QUALITY ASSURANCE -- NON-CONFORMANCE REPORT

Report No: NCR-000742

Component: ED1-A27 Angle Plates on Shear Plate

To:	AMERICAN BRIDGE/FLUOR, A JV 375 BURMA ROAD OAKLAND CA 95607	Date:	25-May-2010
Dear:	Mr. Charles Kanapicki	Contract No:	04-0120F4 04-SF-80-13.2 / 13.9
Attention:	Mr. Thomas Nilsson Project/Fabrication Manager	Job Name:	SAS Superstructure
Subject:	NCR No. ZPMC-0705	Document No:	05.03.06-000700

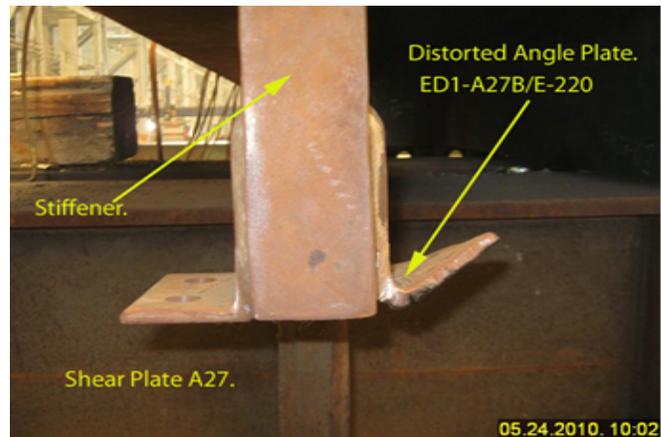
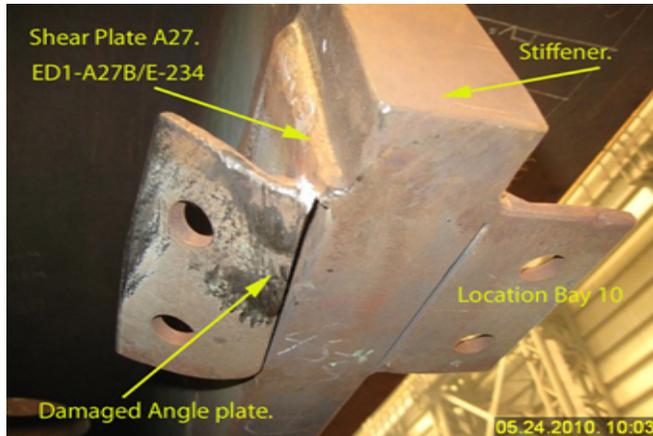
Reference Description: There are two Angle Plates damaged and distorted

During random visual inspection in Bay 10, Quality Assurance Inspector discovered the following issue:

- Two (2) angle plates in the top elevation of Shear Plate were damaged and distorted.
- The welds are identified as ED1-A27B/E-234, 220; fillet weld.
- Tower Lift 1 Shear Plate ED1-A27.
- The member is located in Bay#10.
- These angle plates were previously VT and MT tested.
- The Notice of Witness Inspection Number (NWIT) is 005737.

“In handling and shipping of the steel work, every care shall be taken to avoid bending, scraping or overstressing the pieces. All pieces bent or otherwise injured will be rejected.”

Finished members shall be true to line and free from twists, bends and open joints.

In accordance with Section 55-1.04 of the Standard Specifications, Shear Plate ED1-A27 is rejected due to damaged/ distorted angle plates as referenced in this transmittal.

Please submit a repair plan for the Engineer's approval prior to any remedial work begins.

Reference Resolution: ZPMC will repair these and provide the repair report as well as NDT after to show that the damaged plates have been repaired and are acceptable.

This proposed resolution is accepted with action pending. This NCR will be considered closed once the proper repair report and NDT documentation is submitted and reviewed.

ZPMC has removed the damaged angles and replaced them with new material. ZPMC is providing NDT to show that the welds of the new angles are acceptable as well as an internal ZPMC inspection report. Based on this ZPMC requests closure of this NCR.

This proposed resolution is acceptable. The documentation received is sufficient and the Department concurs that Non-Conformance ZPMC-0705 is closed.
